AI-18207
SURPLUS LOW BOY
DRAINAGE DISTRICT

J. Request approval of Change Order No. 20 on the Contract with SER Construction Partners, LTD. for the Construction of DHS 0-7. Subject to Department of Homeland Security (DHS) concurrence.

CHANGE ORDER NO. 20

Contract No.: 08-009-07-01
Dannenbaum: 4410-02
Change Order No. 20: Change Order No. 20
Description: Extend Bollards

HIDALGO PROTECTIVE LEVEE
 IMPROVEMENT PROJECT
 DHS PF 225-0-6 A

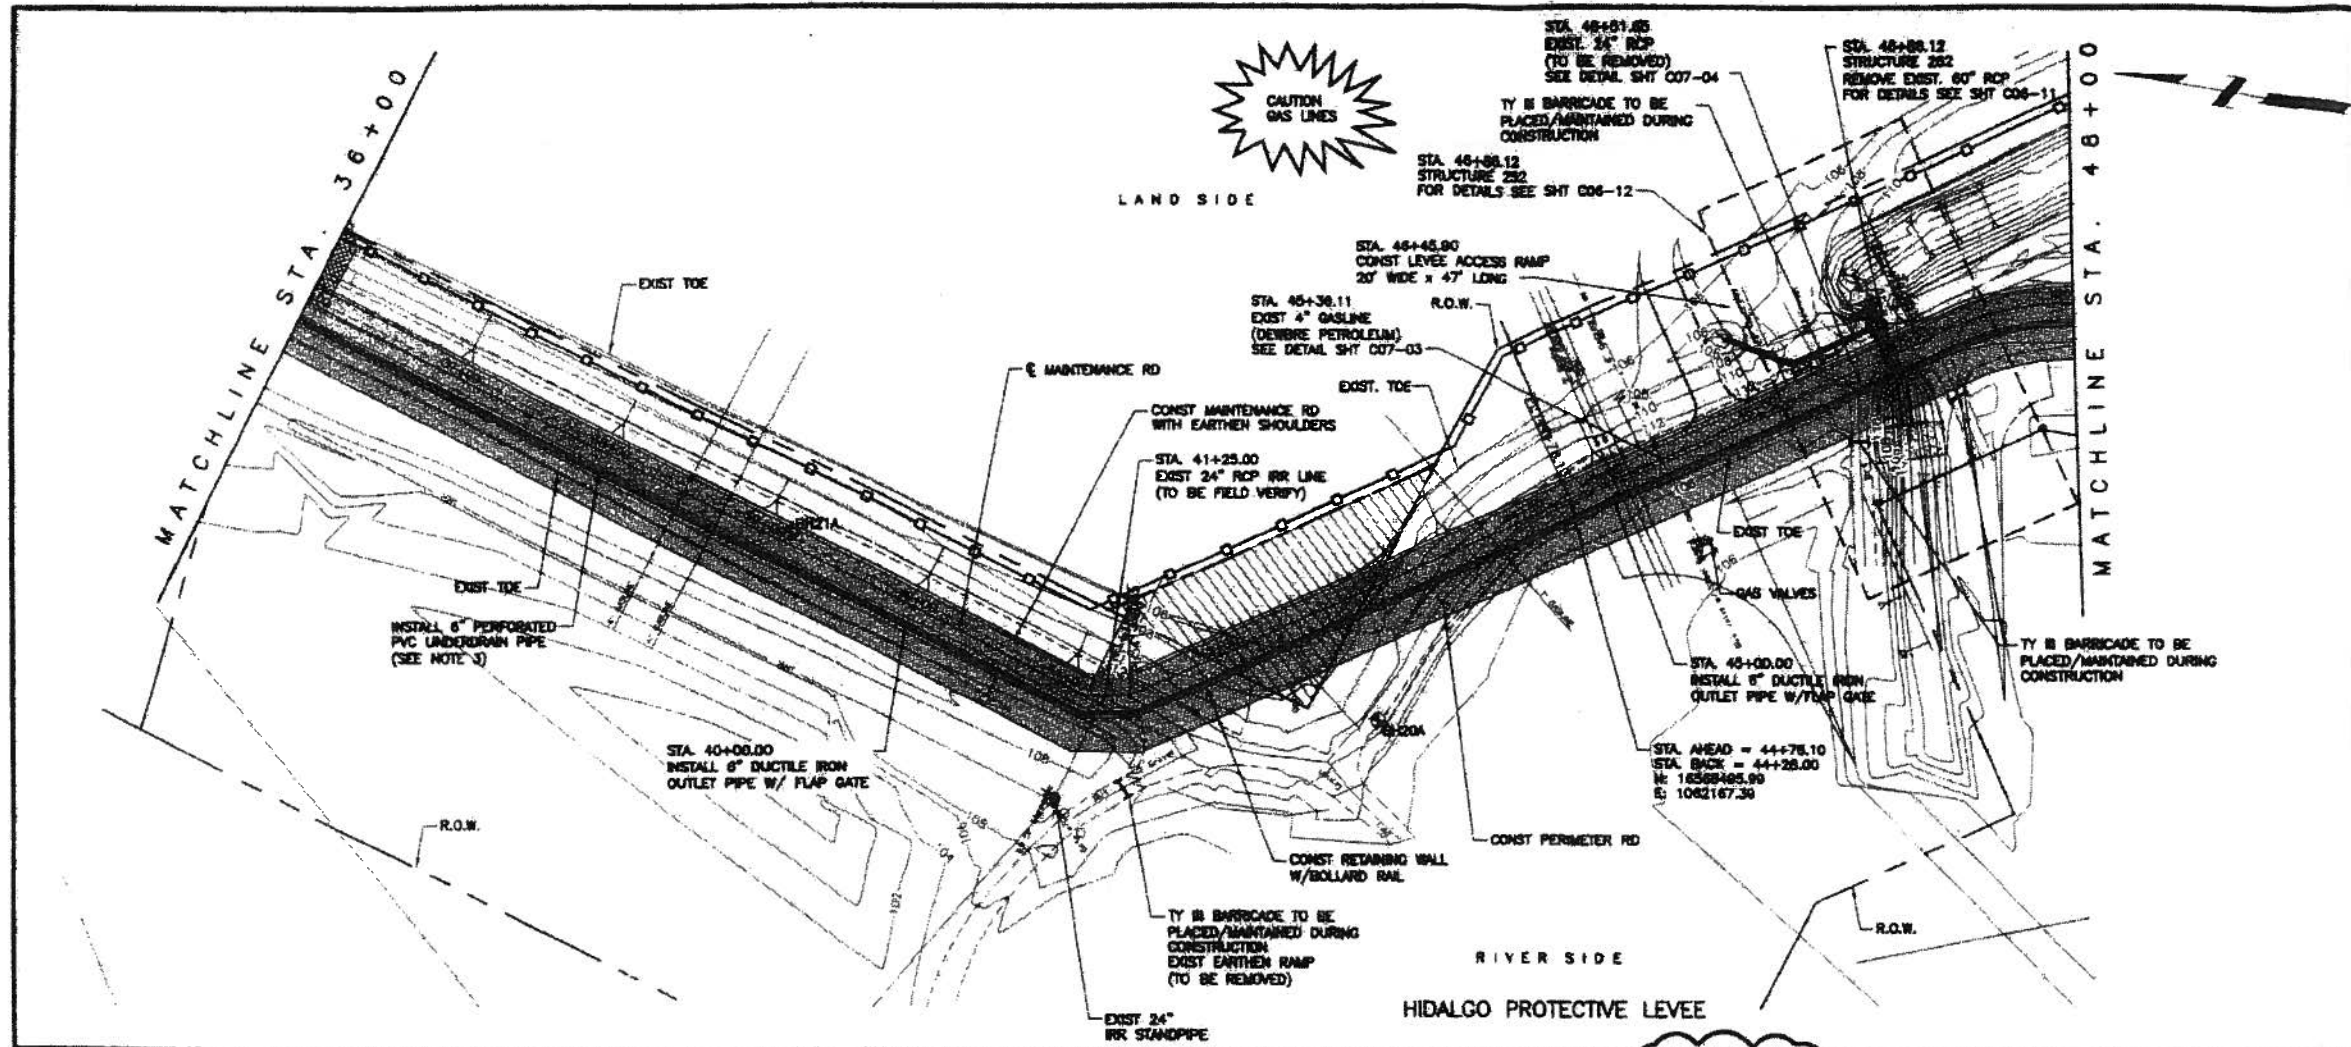
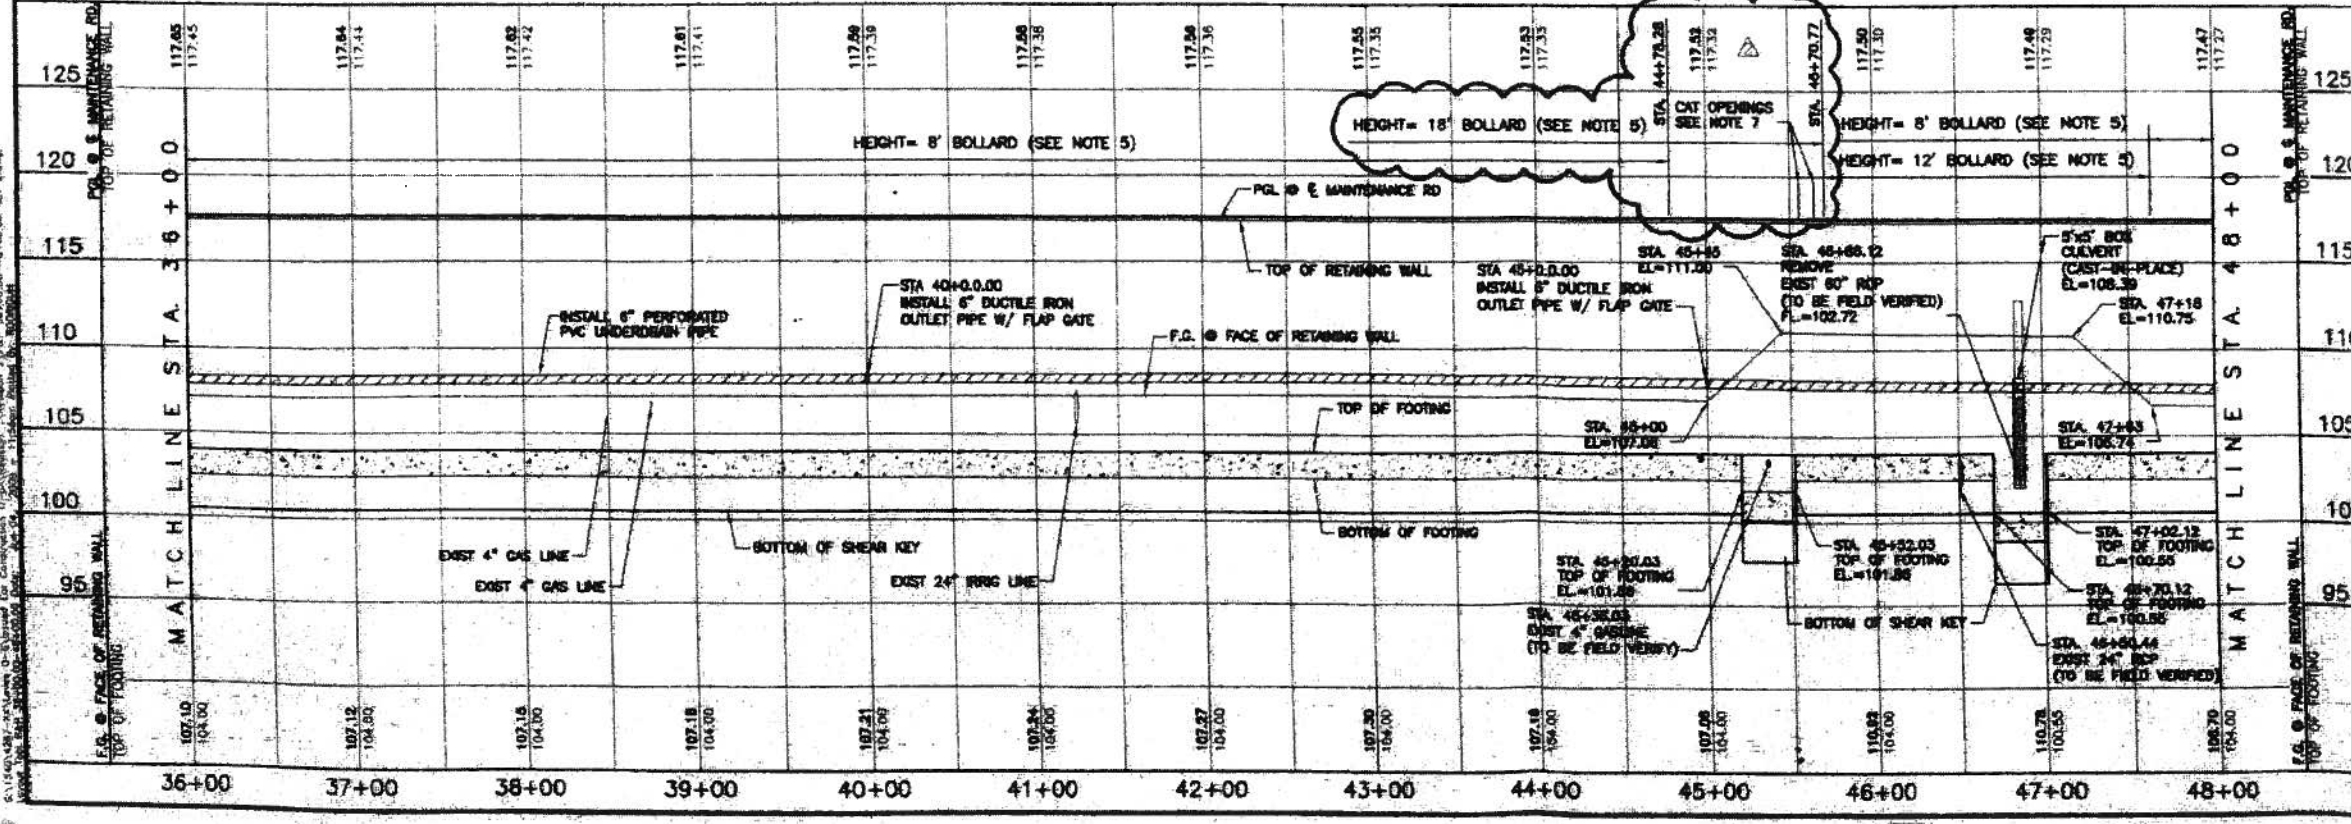
Revision to bollard heights from Sta. 44+78.28 to Sta. 45+70.23.

PLAN & PROFILE SHEET
STA. 144+00 - STA. 156+00

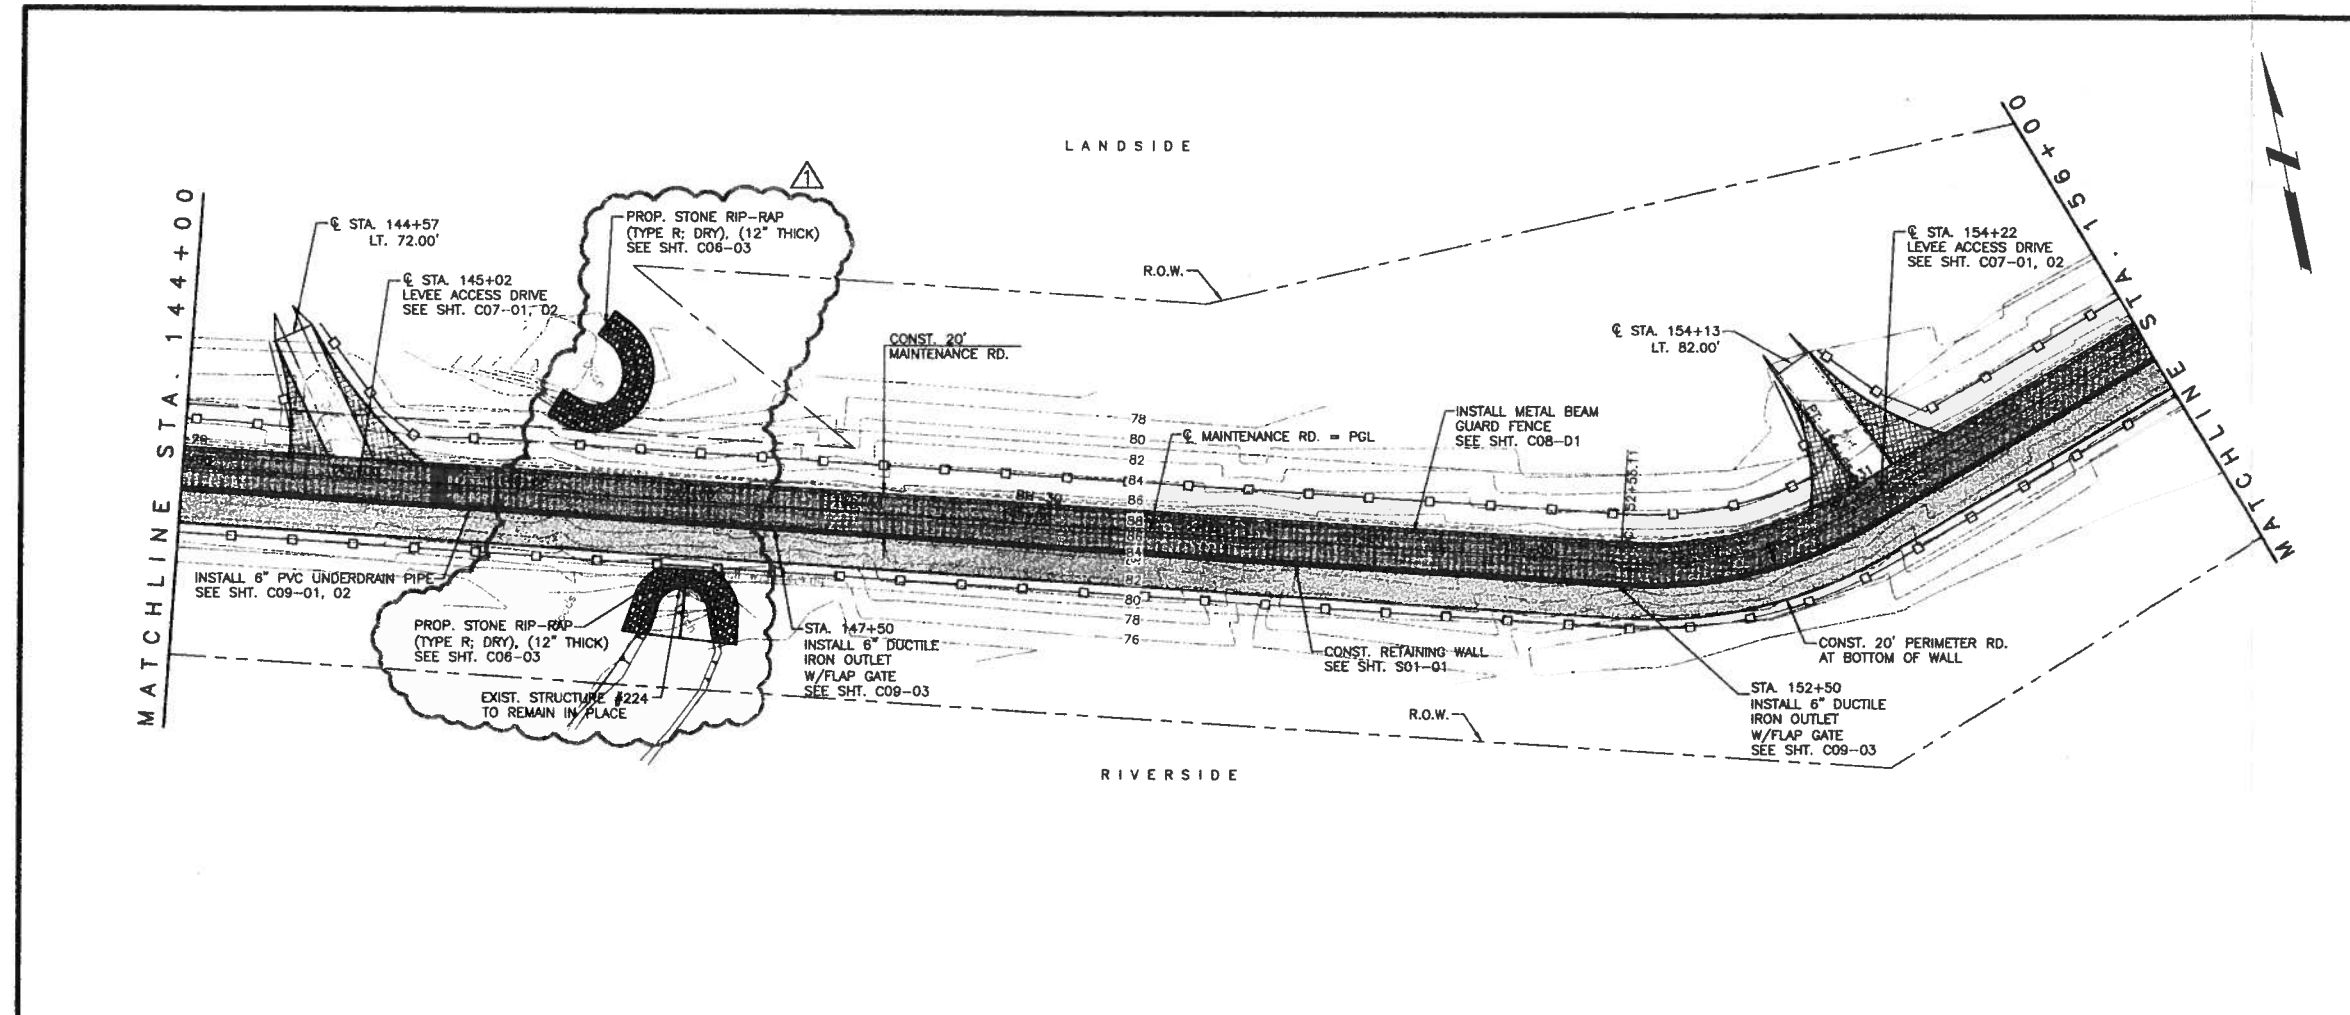
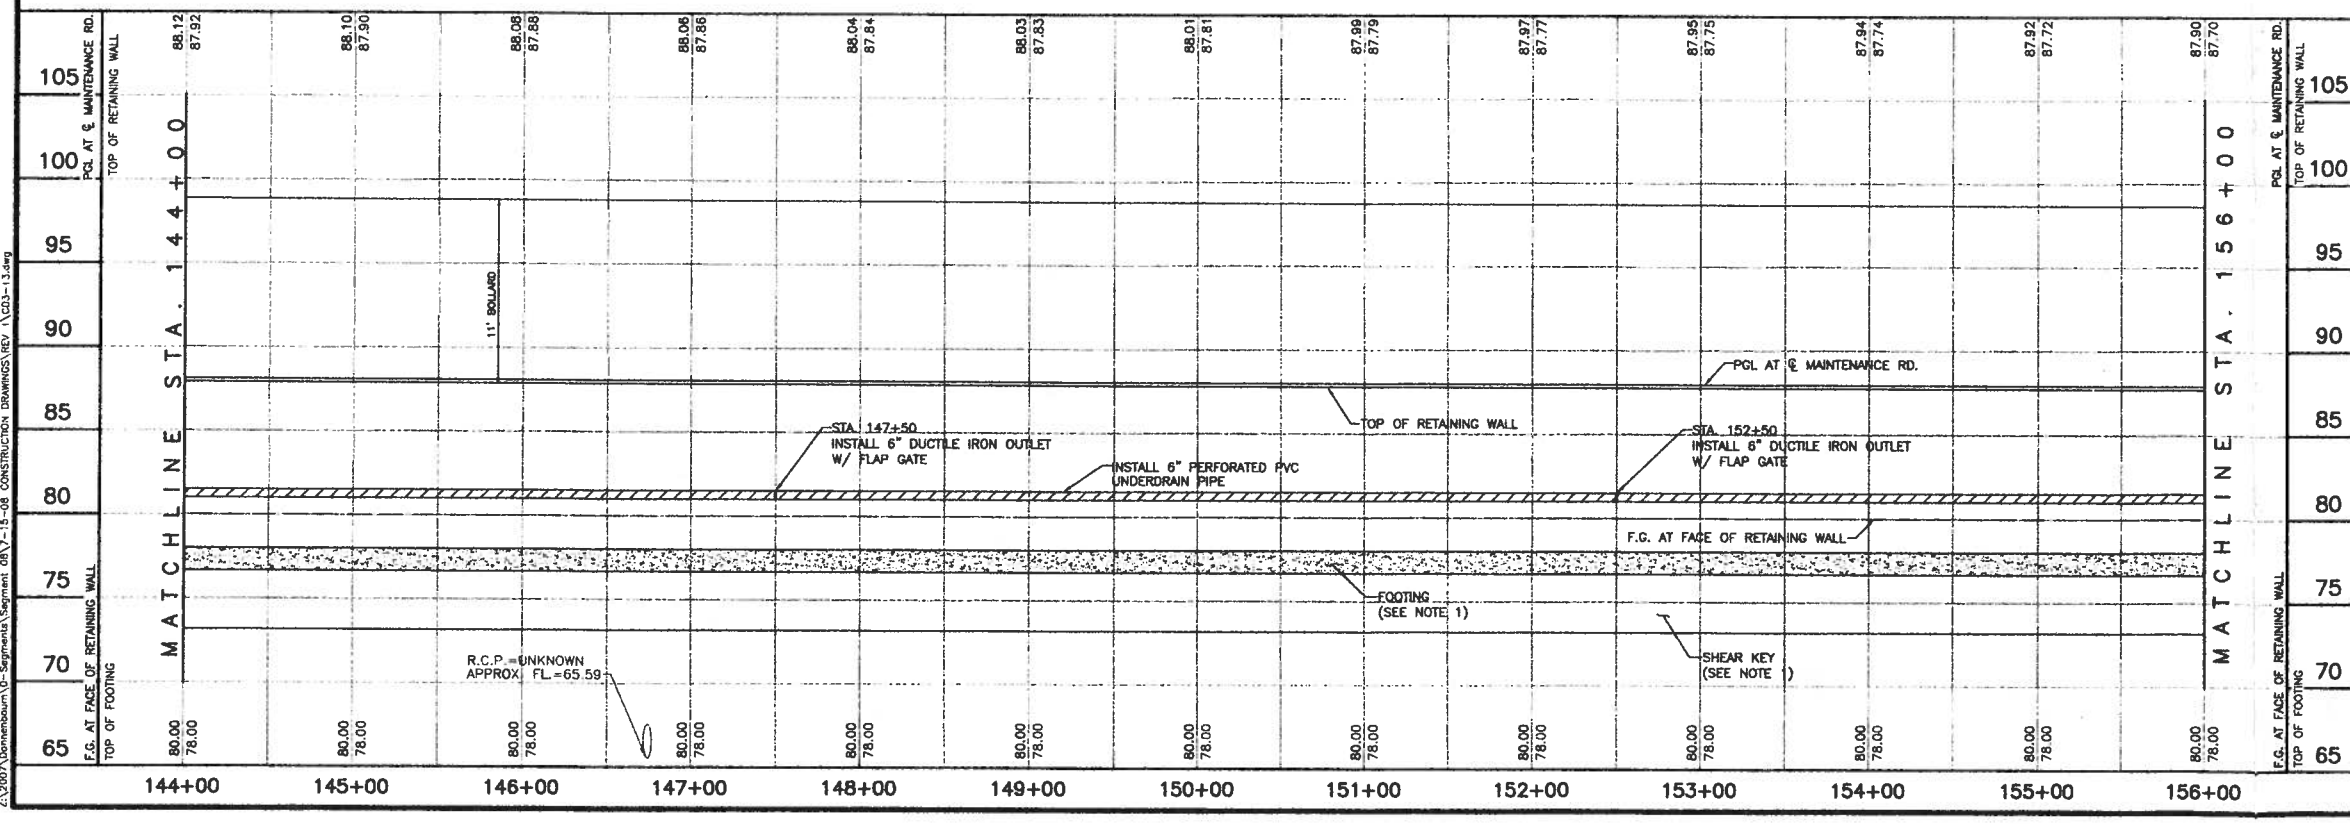
There is currently an Existing Gatewell Structure No. 224 and associated piping and headwalls that was not modified as part of the work of this Contract. It allows water to flow from one area owned by USFW to another. The side slope of the levee on each side of the headwalls steepened due to the raising of the levee. Extreme weather during construction caused unanticipated erosion at the headwalls. In order to prevent further erosion and maintenance of this portion of levee, the Engineer is recommending installation of 12" thick layer of Stone Rip Rap be placed adjacent to each headwall. This Change Order compensated the Contractor for this work.

After Contractor reviewed our "Engineer's Opinion of Cost," it was agreed that our estimate was fair and reasonable. Therefore, Engineer recommends processing of this change order in the amount of \$18,804.89.
